UNITED STATES PATENT AND TRADEMARK OFFICE

Office Action Summary

10/576,963

DETAILED ACTION

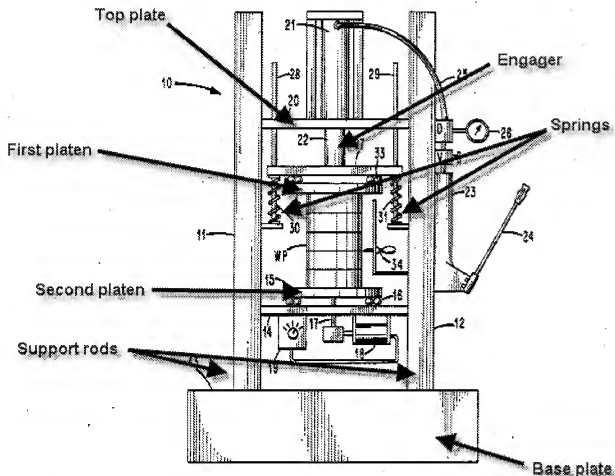
Regarding claim 67, Barry discloses that the thermally assisted bonding unit further comprises a frame having a base plate 13, a top plate 20, and support rods 11, 12 positioned between the bases plate and the top plate, the support rods coupling the top plate and bottom plate, with the engager 22 positioned between the base plate and the top plate; and a first platen 32 and a second platen 15 positioned between the at least one engager and the bottom plate, the first platen contacting an upper surface of the laminae and the second platen contacting a lower surface of the laminae (shown below).
